Access Compliance Report

Public Rights-of-Way

Intersection ID: 11313	Main Street: STAFFORD_DR	Cross Street: WILKINSON_BV	Location: SE
ADA ID: B780CAD48960	Ramp Type: Perp	Initial Pass/Fail: Pass	Overall Compliance: No
		Severity Score: 0

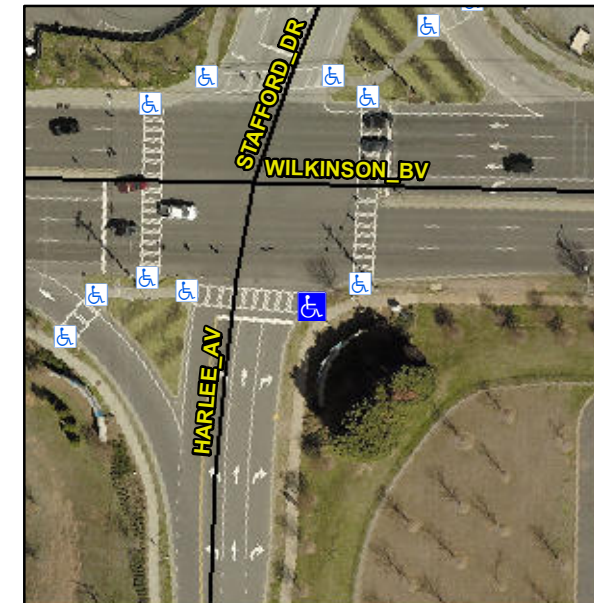
Not Found, R305.2

Remove & Replace Entire Ramp.
